From: John Willoughby <jwilloughby@mkoireland.ie>
Sent: Thursday 8 December 2022 15:04
To: Appeals2
Cc: Lita Clarke; Eoin McCarthy
Subject: ABP Ref. 310789 - Response to Further Information Request - Croagh Wind Farm , County Leitrim (20120)
Attachments: 2022.12.08 - ABP FI Response Cover Letter Leitrim- 180511-c - F.pdf

Our Ref: 180511-c
Your Ref: ABP-310789-21

Re: Response to Request for Further Information – Croagh Wind Farm
Construction of 8 Wind turbines, electrical substation, partial demolition and alteration of two agricultural buildings and all associated site development works, County Leitrim.

RESPONSES TO ABP FURTHER INFORMATION REQUEST

Figure 2.2: Peat probe locations (red dots) for Peat Repository 1 (South)

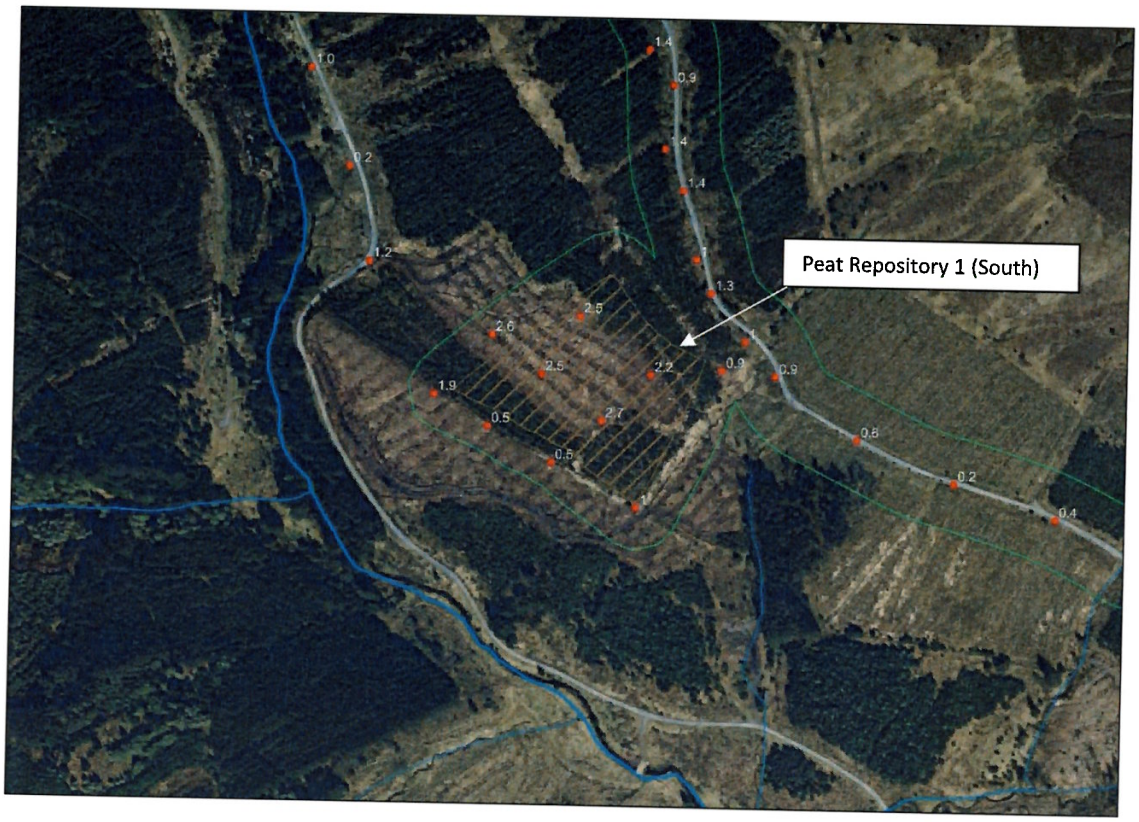
In considering all the information and submissions on file including Chapter 8 of the EIAR, the Peat and Spoil Management Plan submitted as Appendix 4-2 of the EIAR, the Geotechnical and Peat Stability Assessment Report as submitted as Appendix 8-1 and applicant's response to the further information request from the Planning Authority provided as Appendix A Stability Analysis of Borrow Pits, Peat Repositories and Settlement Ponds, the Board could not be satisfied that the proposed repositories would be effective in providing for the permanent retention of peat and other materials and that the mitigation measures, inclusive of the proposed drainage system, would be adequate to ensure that there would be no significant risk of adverse environmental impacts or serious injury to properties in the vicinity of the proposed development.

- Being in locations of relatively shallow peat. Peat depths for the northern repository ranged from 0.3 to 1m (Figure 2.2), from 0.6 to 2.7m at the southern repository (1.7m on average, Figure 2.3), and 0.5 to 1.7m at the borrow pit (average of 1.2m, Figure 2.4) compared to a range of 0 to 8.2m and an average peat depth of 2.2m across the entire site. This is important because all peat below the proposed perimeter berms around the repositories has to be removed to provide a competent base for the berms, and if the peat is too deep then all of the storage space within the repository would be needed to store the peat excavated from beneath the berms

Figure A: Proposed Drainage at the most Northern Peat Repository and showing the Killanummery stream (Abstract of Drainage Drawing 0511-23 Rev B)

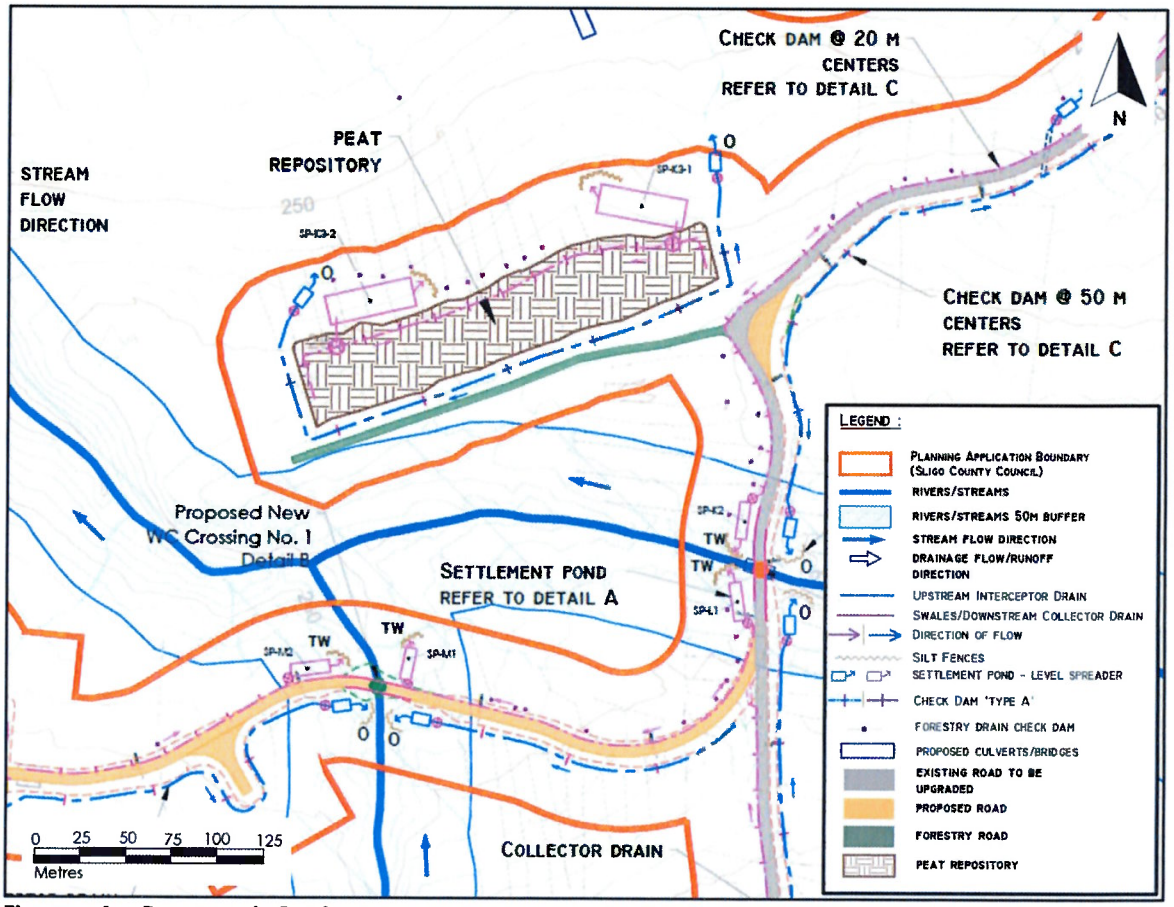
> *"In considering all the information and submissions on the file including Chapter 8 of the EIAR, the Peat and Spoil Management Plan submitted as Appendix 4-2 of the EIAR, the Geotechnical and Peat Stability Assessment Report submitted as Appendix 8-1 of the EIAR and the applicant's response to the further information request from the Planning Authority provided as Appendix A Stability Analysis of Borrow Pits, Peat Repositories and Settlement Ponds, the Board could not be satisfied that the proposed repositories would be effective in providing for the permanent retention of peat and other materials and that the mitigation measures, inclusive of the proposed drainage system, would be adequate to ensure that there would be no significant risk of adverse environmental impacts or serious injury to properties in the vicinity of the proposed development ".*

- The repositories will be enclosed areas, and as such associated drainage can be easily contained and managed;
- Drainage from the repositories will be directed to settlement ponds as shown in **Figure A** and **Figure B** below; (Please note that all settlement pond locations were subject to a geotechnical assessment, refer to Appendix 3 of FIR P. 20/120 and Appendix 2 of FIR PL. 20/251);
